UNITED STATES PATENT AND TRADEMARK OFFICE

APPLICATION NO.	FILING DATE	FIRST NAMED INVENTOR	ATTORNEY DOCKET NO.	CONFIRMATION NO.
10/678,956	10/03/2003	Mikio Naruse	116-031937	7292
28289	7590	08/23/2005		
THE WEBB LAW FIRM, P.C. 700 KOPPERS BUILDING 436 SEVENTH AVENUE PITTSBURGH, PA 15219				EXAMINER JOHNSTON, PHILLIP A
				ART UNIT 2881
				PAPER NUMBER

Office Action Summary	Application No.	Applicant(s)	
	10/678,956	NARUSE, MIKIO	
	Examiner	Art Unit	
	Phillip A. Johnston	2881

Claims Rejection – 35 U.S.C. 103

Fig. 1

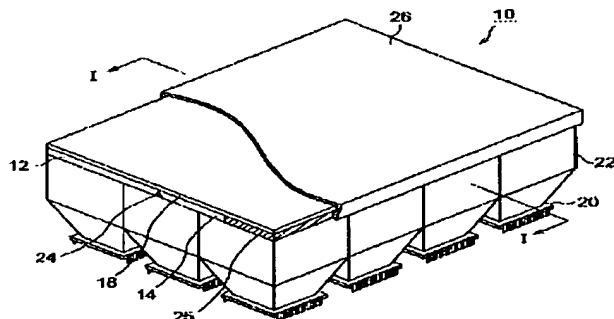
(a) Radiation image sensor 10 that includes a scintillator 18 deposited (grown) on the entrance end faces 12a, 14a of optical members 12, 14; a plurality of CCDs 20 (imaging devices) for capturing optical images outputted from exit end faces 12b, 14b of the optical members 12, 14; and a plurality of light-guiding optical components 22 for guiding to the CCDs 20 the optical images outputted from the exit end faces 12b, 14b of optical members 12, 14, as recited in claims 1, 6, and 7. See paragraph [0025]; and Figure 1 below;

Fig.2

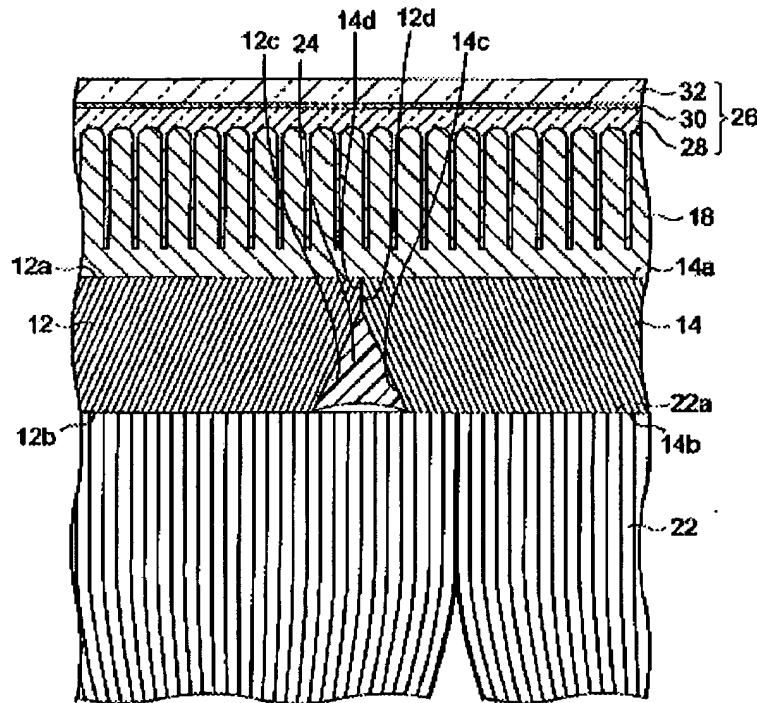
(c) Fiber bundles 22 bent out and away from the optical axis, as recited in claim 4. See Figure 2 below.

(d) Seamless end faces 14d and 14c ground and polished, as recited in claim 4. see paragraph [0053] and Figure 2 above;

(e) Optical members 12 and 14 are formed by arranging a plurality of optical fibers sliced obliquely with respect to the optical fiber axis. As a result, the obliquely cut optical fiber entrance faces 12a and 14a of members 12 and 14 are in contact with scintillator 18 and the exit faces are integrally molded to the fiber light guides 22, as recited in claims 2 and 3. See paragraph [0044]; and Figure 2 above.

FIG. 1

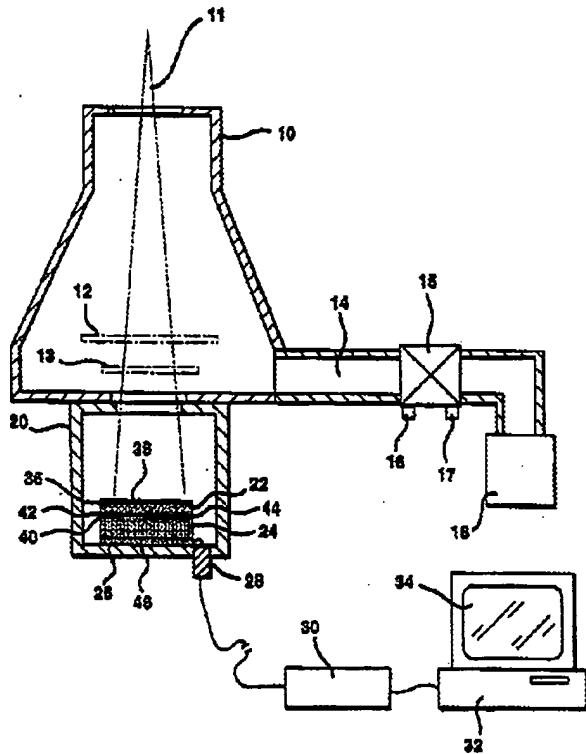
Kusuyama (694) as applied above fails to teach the projection of a TEM (Transmission Electron Microscope) image onto the sensitive surfaces of a radiation imaging detector that utilizes plural CCD elements. However, Mooney (720) discloses an imaging apparatus utilizing CCD's that is mounted in the projection chamber of a transmission electron microscope, as recited in claims 1,6, and 7. See Column 3, line 9-33; and Figure 1 below.

Therefore it would have been obvious to one of ordinary skill in the art that the radiation imaging detector and method of Kusuyama (694) can be modified for use in the Transmission Electron Microscope of Mooney (720), to provide a detector

designed to be positioned in the projection chamber of an electron microscope to detect electron images and/or diffraction patterns from a sample and convert those electron images into light images.
